In the matter of an application for Resource Consents by Lumo Digital Limited
to construct a digital billboard display at 399 Lincoln Road

Evidence summary of Axel Downard-Wilke
Senior Traffic Engineer and Transport Planner
for
Christchurch City Council
1 December 2020

Christchurch City Council's reporting officer's comments for the hearing of RMA/2020/702 - establish and operate two digital billboards at 399 Lincoln Road, Addington

Figure 1: estimating crash rates with 95% confidence limits – example

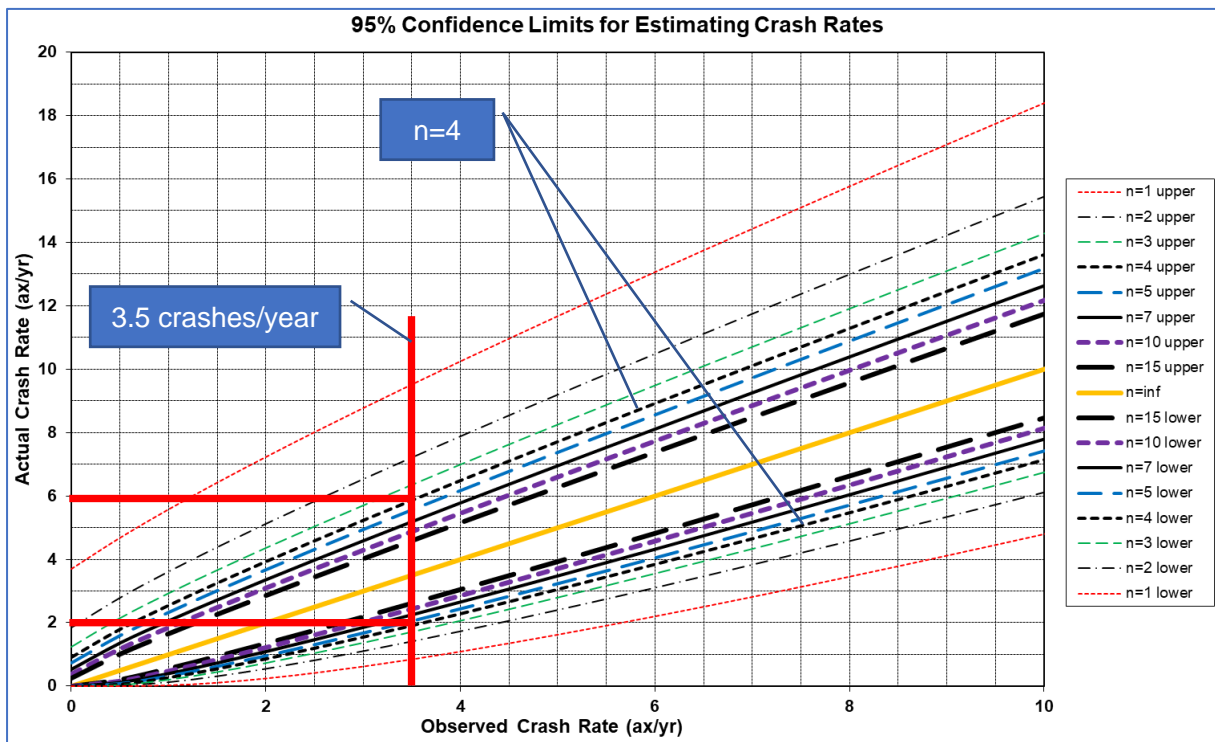
9. The chart in Figure 1 is provided in response to Mr Rossiter's evidence. It is a tool for estimating crash rates within 95% confidence limits, based on a Poisson statistical distribution. It includes a hypothetical example where the analysis was done for a 4-year period ($n=4$, i.e. the black dotted lines fourth from the outer line) and revealed an average crash rate of 3.5 crashes per year (the vertical line crossing the x-axis at 3.5). In this

scenario, the 95% confidence limits for that crash rate has an upper limit of 6 crashes per year, and a lower limit of 2 crashes per year (i.e. where the horizontal lines intercept the $n=4$ lines at $x=3.5$). A statistically significant change in crash rate would thus require having more than 6 or less than 2 crashes per year, which is a wide variation to the observed 3.5 crashes per year beforehand. This example shows that it is almost impossible to draw statistically relevant conclusions from crash observations at a single site, as was attempted by Mr Rossiter with the Blenheim Road example. It is therefore necessary to have either a much larger sample of sites or employ a different metric (for example behavioural events which are much more common than crashes).

Figure 2: tracking analysis for a semi-trailer

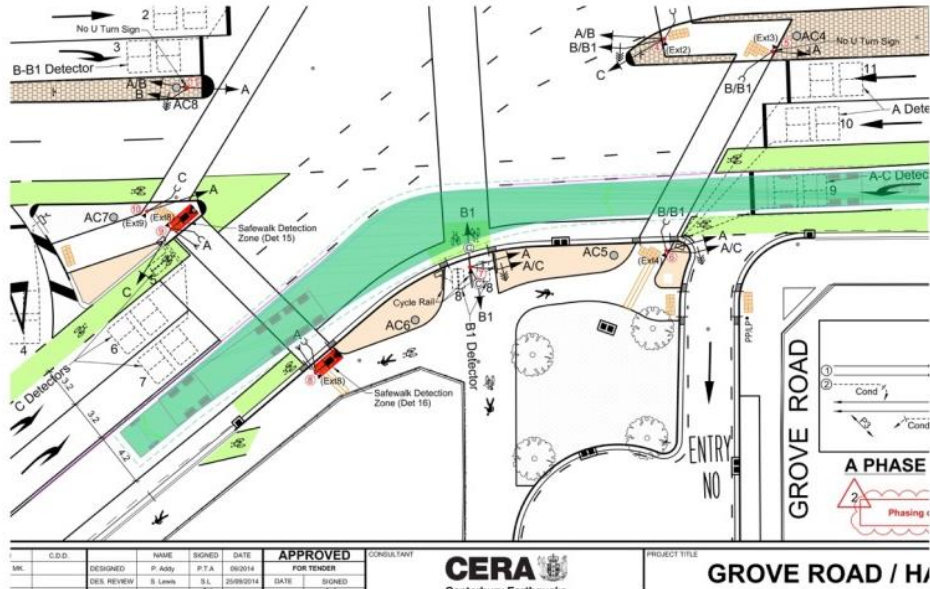
32. ViaStrada's peer review mentions the issue of drivers cutting into the cycle lane when turning, and that this may happen inadvertently when a driver is distracted. An issue that the peer review does not list is that a semi-trailer turning left from Moorhouse into Lincoln would have to swing wide in order to stay out of the cycle lane (that is, the vehicle would have to go over the centre line into the line of oncoming traffic). The problem is that it is not always possible to swing across the centre line, as right turners out of Lincoln move simultaneously as the left turners into Lincoln during the intersection's C-phase (refer to Figure 2-2 in our peer review). Therefore, very large vehicles must utilise the cycle lane almost to the fender as they otherwise do not fit round this bend (see Figure 2).

33. It is acknowledged that this situation is not of the Applicant's making. However, truck drivers getting distracted by the billboard may face a higher likelihood of overlooking a person on a bike. Incidents of this type may be infrequent, but should they occur, a fatal outcome is likely, which makes this a moderate issue in the concern assessment rating matrix used for safety auditing.

35. Should consent be granted, I recommend that one of the conditions is that the applicant contribute towards establishing the cycle safety improvements in this location, and that the billboard be switched on only after this part of the work has been completed. That said, these improvements will not address other safety concerns that remain.
